Subject: Braidwood Station Unit 1
NRC Docket Number: 50-456

Operating Interval Between Eddy Current Inspections for Circumferential
Indications in the Braidwood Unit 1 Steam Generators

REQUEST FOR ADDITIONAL INFORMATION
RELATED TO THE PROPOSED DELETION OF THE
BRAIDWOOD, UNIT 1 MID-CYCLE STEAM GENERATOR TUBE INSPECTION
DOCKET NO. STN 50-456

Figure 5a

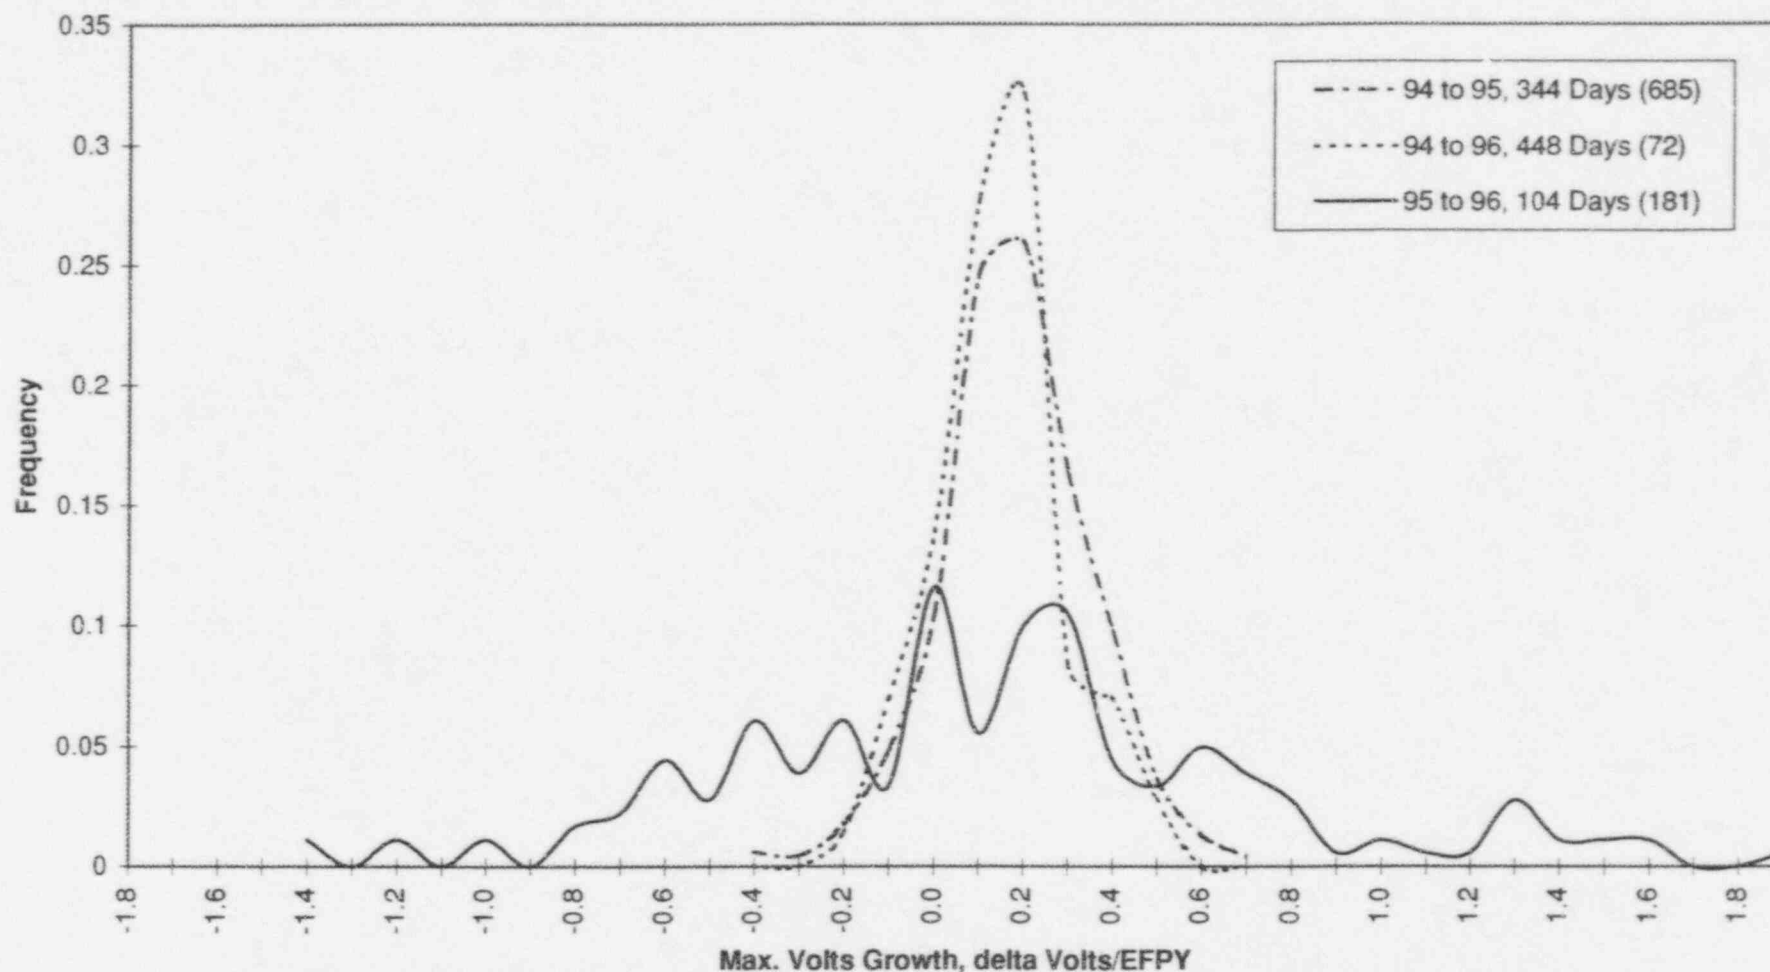
5. Several values important in assessing the end-of-cycle (EOC) structural and leakage integrity of Braidwood 1 SG tubes been modified since the submittal dated August 2, 1996. For example, the burst and leakage correlation's in response to the prior RAI have been adjusted to account for industry material property data and revised values for analyst error. Accordingly, re-evaluate the Braidwood 1 EOC assessment considering all changes to the proposed methodology. Address the use of bounding voltage correction values as discussed in Item 3 above and the limiting growth rate distribution in light of the responses to Items 2 and 3 of the prior RAI.

The distribution of growth rates shown in Figures 5a and 5b provide the following observations: the growth rate distributions for longer intervals, approximately one full cycle of operation (1994 to 1995 and 1994 to 1996), are smooth with relatively short tails and is peaked at the middle. The distribution for the short operating interval, approximately one quarter of an operating cycle (1995 to 1996) is not smooth, has long tails in both directions and is flat. The curves on the figures show that there is a significant difference in the short and long cycle growth rates.
